ADDENDUM NO. 4
TO THE CONTRACT DOCUMENTS
for the construction of

Date: January 12, 2018
Project No.: 664737

Friar's Branch – South Chickamauga Creek 5 Interceptor Rehabilitation
Contract No. W-15-002-201

MANHOLE BASE SECTION - 27" TO 72" PIPE

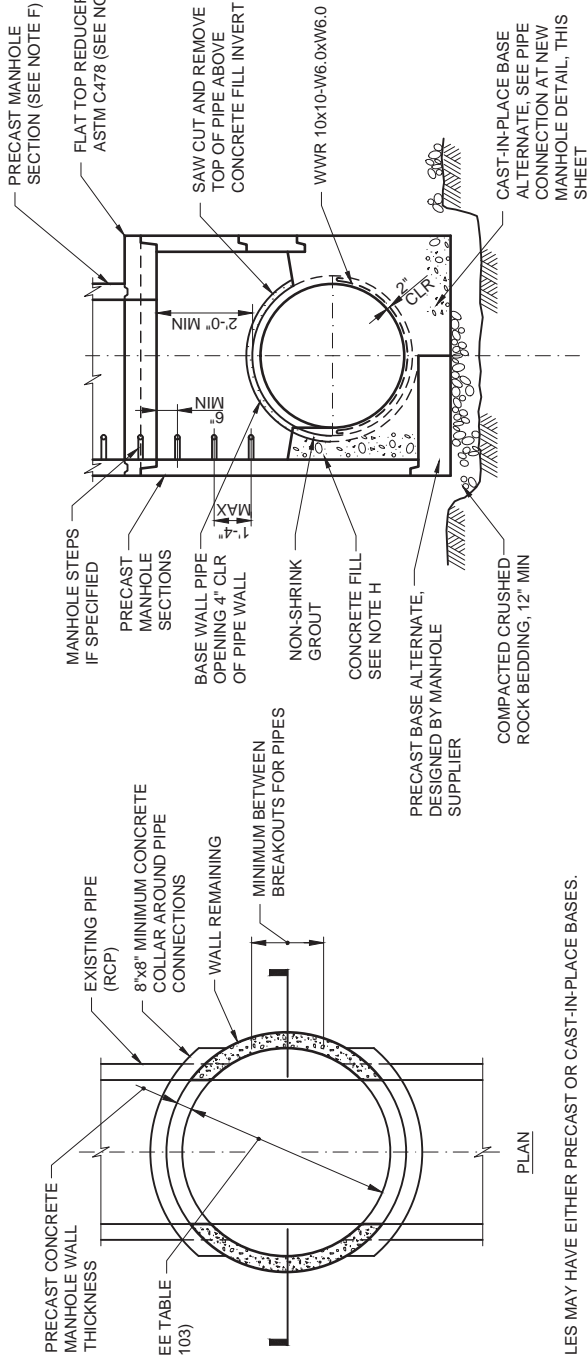
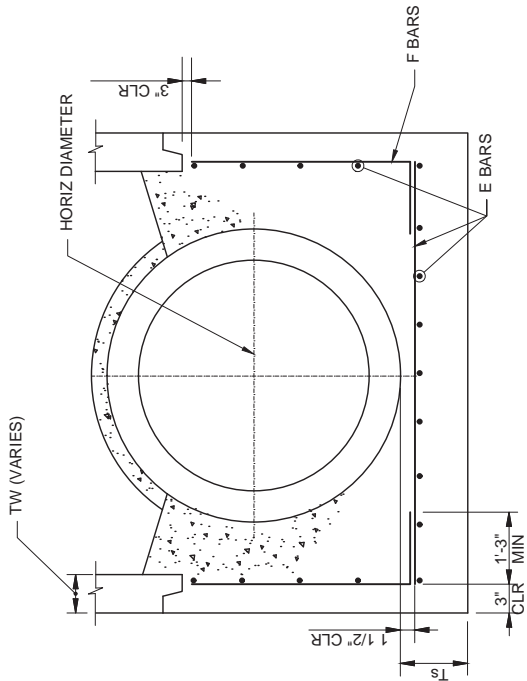
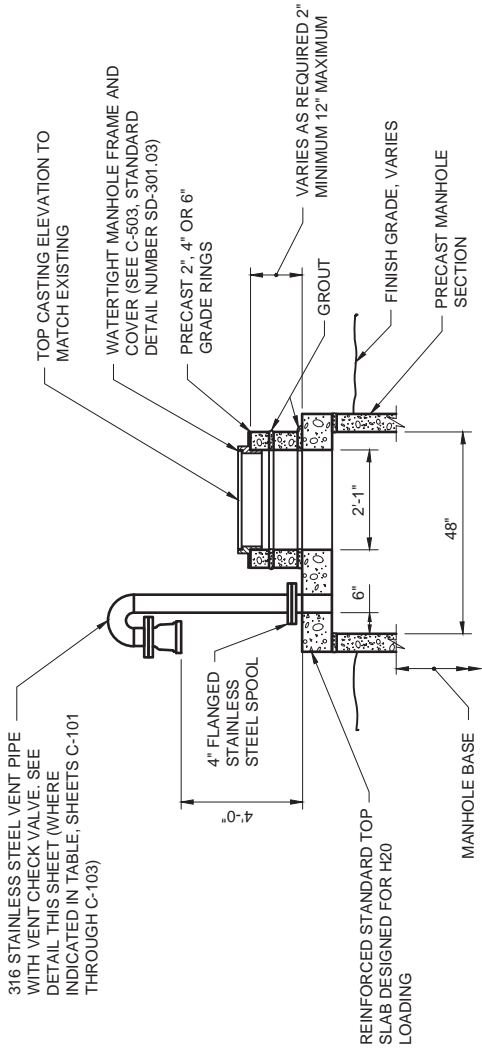
Response: Structure diameters will be dependent upon field verified pipe diameters and pipe deflection angles; minimum diameters are not provided. A revised sheet C-508 is included with this Addendum. The Cast-In-Place Manhole Base detail has been revised.

1. Sheet C-508 is replaced. The revised sheet has "Addendum 4" in the lower left of the page. The Cast-In-Place Manhole Base detail has been revised.
2. Replace the Bid Form with the revised Bid Form, with "Addendum 4" indicated in the header at the top left of each page. S148A006 has been lined and the quantity for this segment has been removed. Manholes S147D009 and S148001 have been rehabilitated, therefore, they shall not be included in the project as New Manholes. Pay Item 8 has been changed.

FLAT TOP MANHOLE

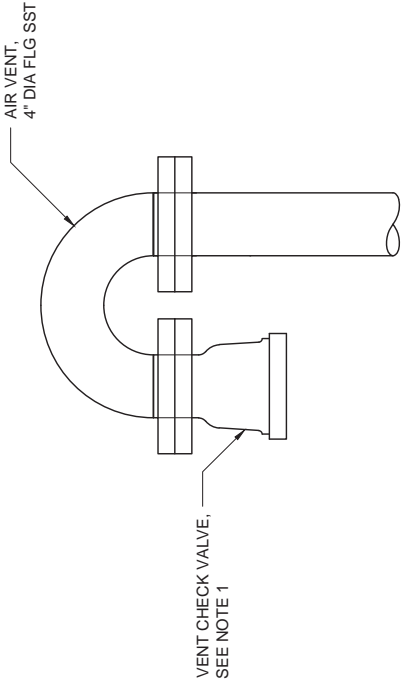
- 1) Replace Existing Frame and Cover with New Watertight Frame and Cover to Include Internal Frame-Chimney Seal.
 - 2) If any manhole that is to be rehabilitated has a vent pipe, the following is required: replace existing cone with standard riser and flat top with vent pipe to include external wrap and internal frame-chimney seal, in accordance with the plan detail, Flat Top Manhole, on sheet C-508.
